CRITICAL ELEMENTS LITHIUM CORPORATION

**LITHIUM-TANTALUM ROSE PROJECT –
ANSWERS TO THE NON-COMPLIANCE OF THE
SECOND INFORMATION REQUEST FROM THE
IAAC**

IAAC FILE 005327

DATE : DECEMBER 2020

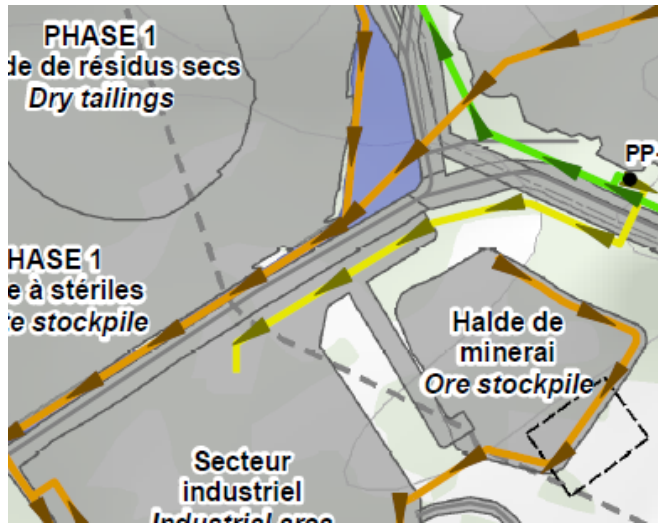
- B) *The proponent must explain what the blue zone represents to the east of the co-deposition pile on map 03-03 of Appendix CEAA-21 and what are the design and waterproofing criteria planned for this infrastructure. It must also indicate what is the correct value of Manning's coefficient, or explain the difference between the two values presented in the sponsor's response documents.*

The blue area east of the co-depositing stockpile on Map 03-03 of Schedule CEEA-21 (see close-up below) represents a ditch that collects contact water from both the co-depositing pile and the haul road. In detail engineering, this ditch can be optimized and reduced as required.
